10/790,384

Office Action Summary

STEWART, GLEN HARRIS

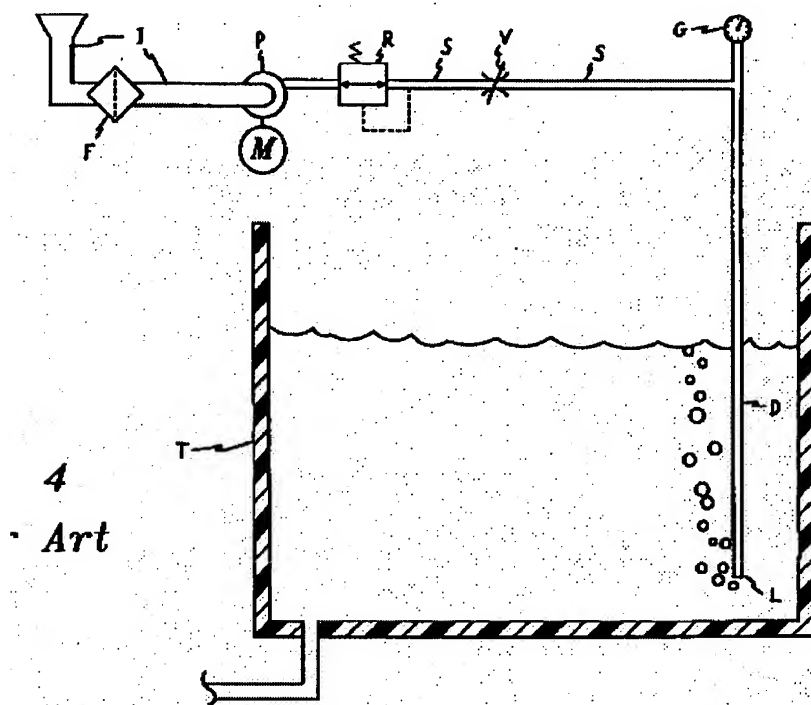
4. Claims 1-3 are rejected under 35 U.S.C. 102(b) as being anticipated by Van Ee (U.S. 6,510,736). In his admitted prior art of figure 4, Van Ee teaches a level sensor comprising an

aeration tube D extending adjacent a bottom of the holding tank T. A pressure gauge G is sealed to the tube to determine the level in the tank (col. 9, lines 52-57). An air pump P is connected to the tube via an air supply line S to continuously pump air into the tank [as in claim 2]. The

limitations in the last three lines of claim 3 is considered to be an intended use thereof that fails to further limit the structure of the invention. However, it is contended that Van Ee has the structural components to accomplish such depending upon the environment in which it is used (identity of fluid therein, etc.).

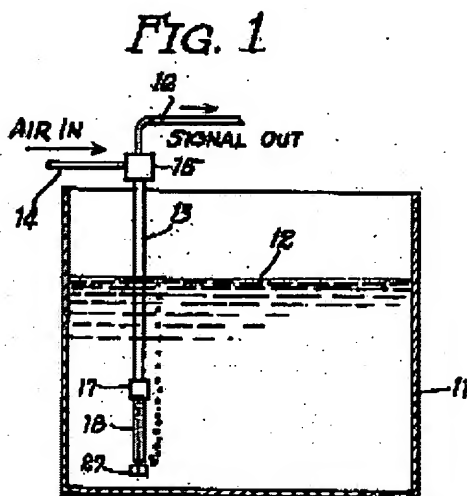
5. Claim 1 is rejected under 35 U.S.C. 102(b) as being anticipated by Kapteyn (U.S. 3,587,316). Line 16 is sealingly connected to the pressure gauge to indicate the level.

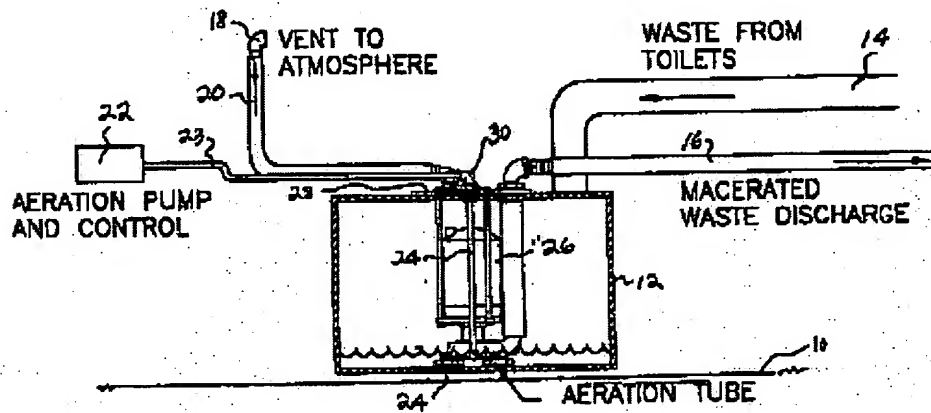
7. Claims 1-3 are rejected under 35 U.S.C. 103(a) as being unpatentable over Gross (U.S. 6,702,938 B2) in view of Van Ee '736. Gross teaches a waste holding tank, aeration pump, and aeration tube.

Gross doesn't teach a pressure monitoring means. However, as expanded above, such is taught by Van Ee. It is considered that it would have been obvious to one ordinarily skilled in the art at the time of the invention to have the pressure monitoring means of Van Ee in the invention of Gross, since such would provide the benefit of monitoring the fluid level in the tank.
